January 26, 1994

Joseph M. Farley Nuclear Plant
Request for Additional Information Regarding
Southern Nuclear Operating Company Responses To
Issues Related to FNP Electrical Distribution System Functional Inspection

Request for Additional Information Regarding Southern Nuclear Operating Company Responses To Issues Related to FNP Electrical Distribution System Functional Inspection

KODAK SEMI-LOGARITHMIC 3 CYCLES X 1/2 DIVISION KEUFFEL & ESSER CO. MADE IN U.S.A.

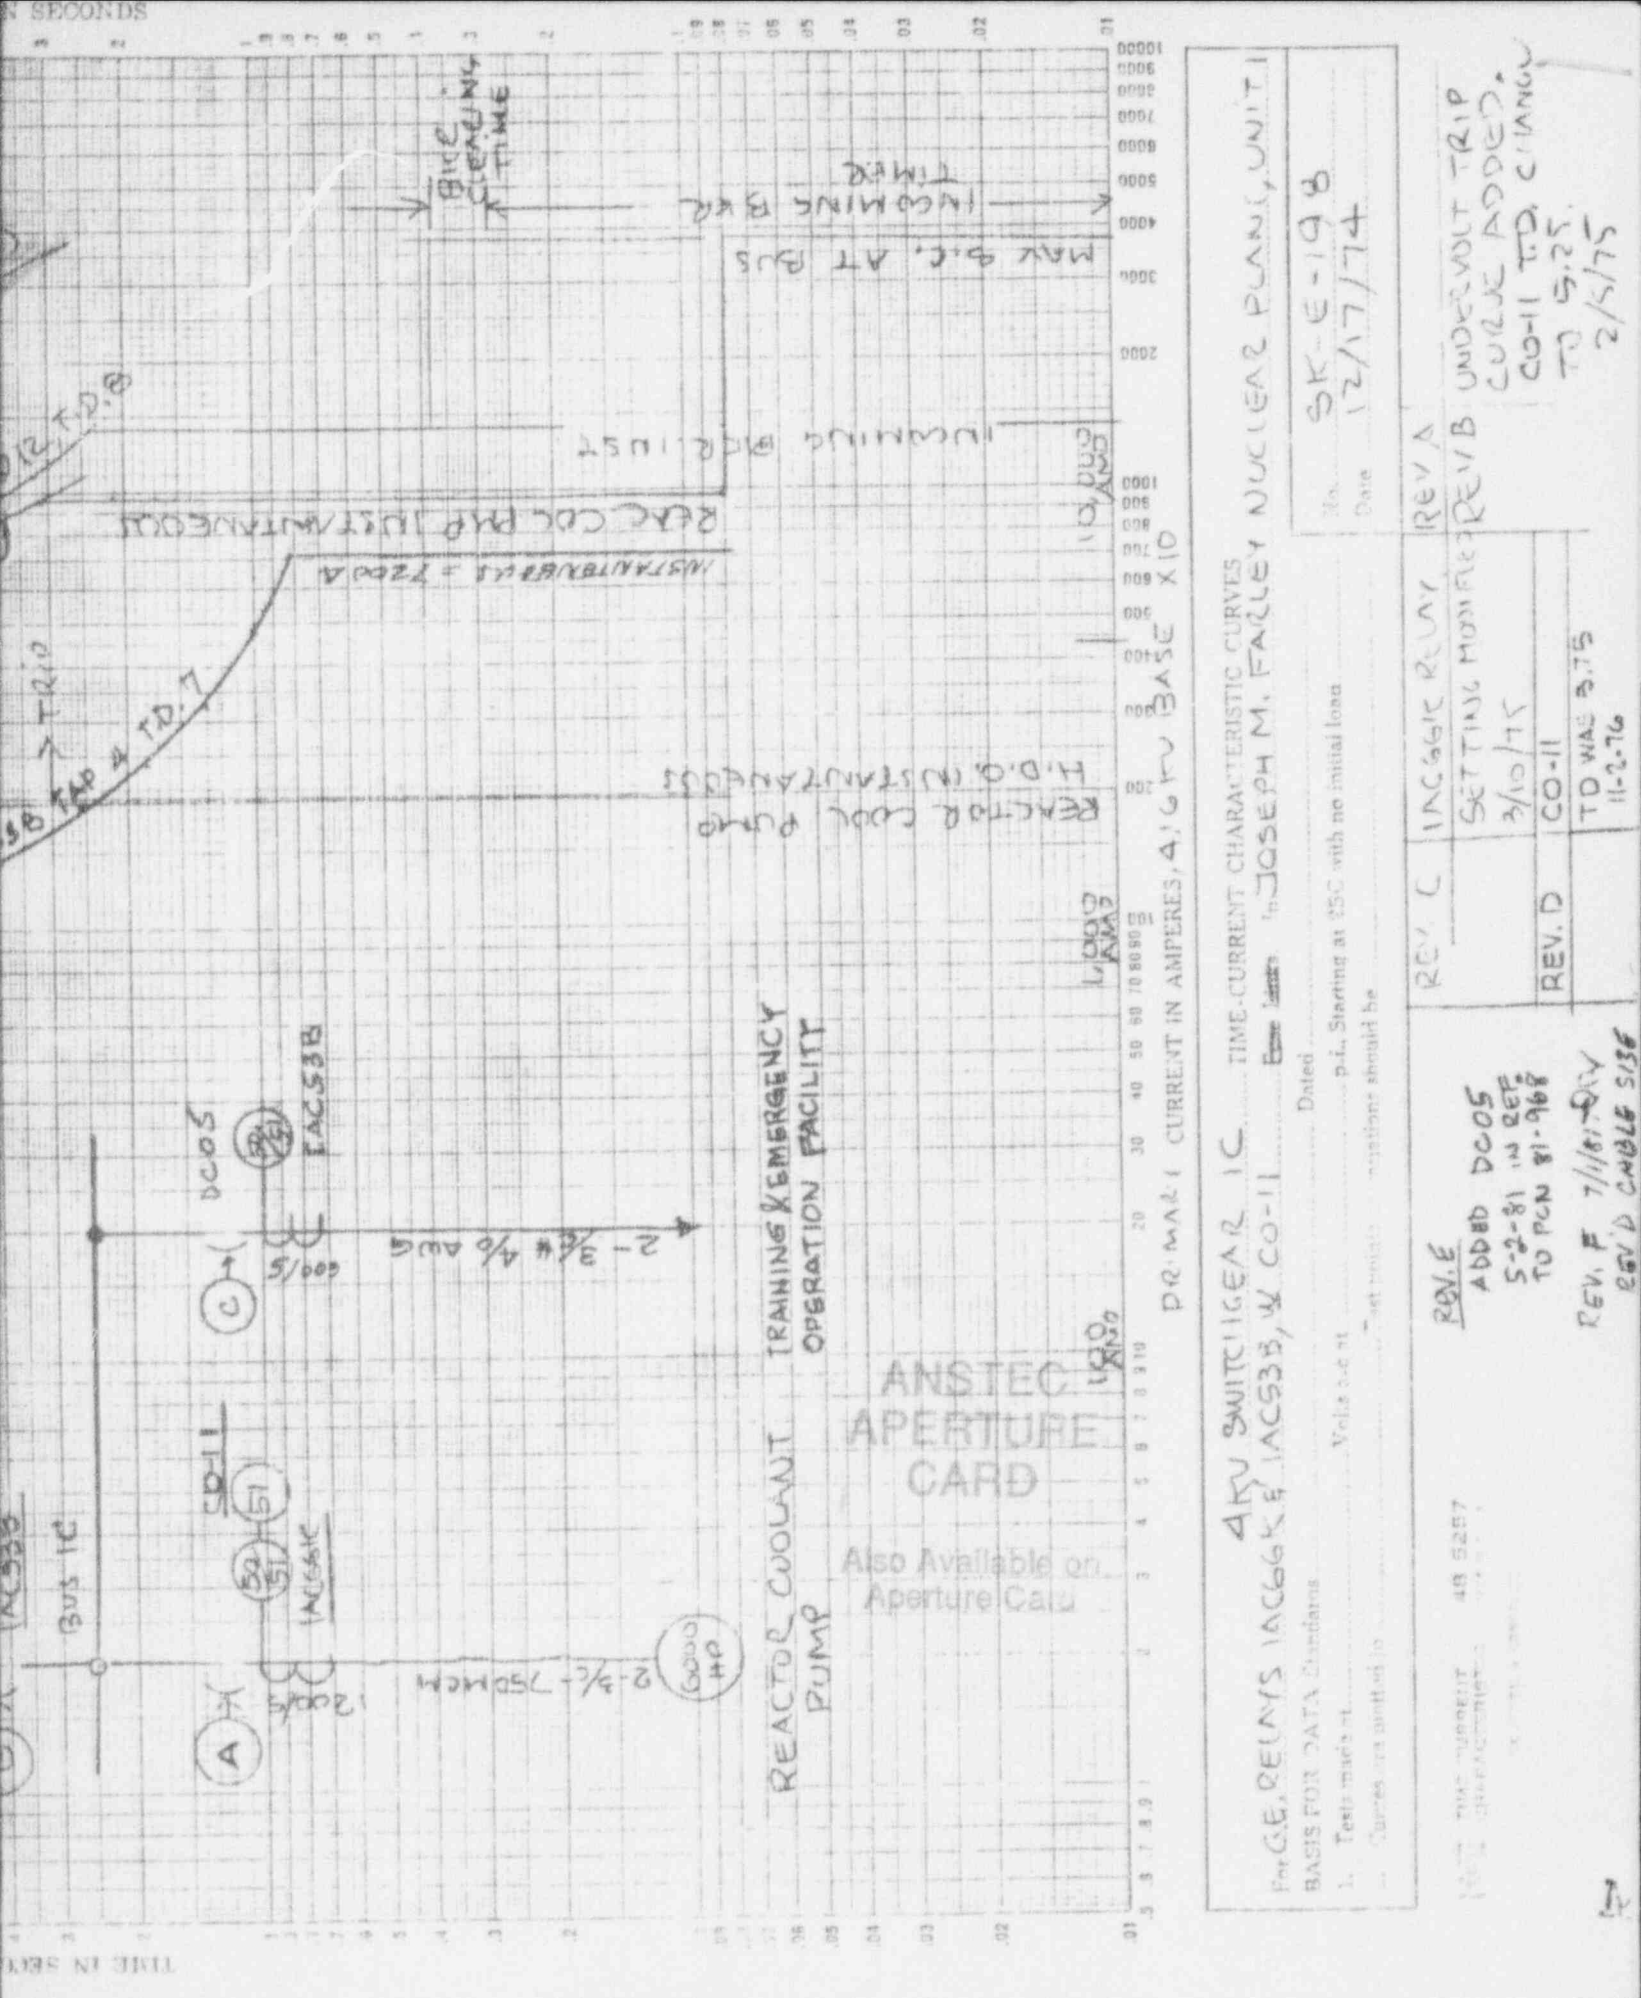
Provide time-current characteristic curves for equipment items associated with the reactor coolant pump motors. The response should include: (1) inrush current (I_s) curves with 80 percent and 100 percent bus voltage available, (2) both relay curves used for the RCP motor protection (IAC66K and CO11), (3) thermal limit curves for RCP motor stator and rotor windings, (4) RCP motor bus upstream main breaker thermal limit curves, (5) RCP motor

cable thermal limit curves, (6) containment penetration thermal limit curves, and (7) fuse thermal limit curves, if fuses are connected in series between the RCP motor feeder breaker and the RCP motor. In addition, provide relay trip setpoints for protective relays IAC66K and CO11.

As discussed in the SNC response to EDSFI issues dated November 5, 1993, the FNP design provides motor winding temperature alarms to ensure protection during motor running (i.e., normal operation below 2000 amps). During motor starting, protection is provided by the combination of IAC66K relay and the CO-11 relay. This combination provides complete protection from approaching the motor thermal limit from 2000 amps to approximately 3700 amps. Above 3700 amps it is possible to exceed the RCP motor thermal limit for a few seconds prior to protective relay actuation. Although this relaying scheme does not afford complete protection from exceeding the thermal limit, this scheme was determined to be optimal, in terms of maximizing motor protection while limiting nuisance trips, during plant design and startup. Experience has confirmed these settings to be adequate.
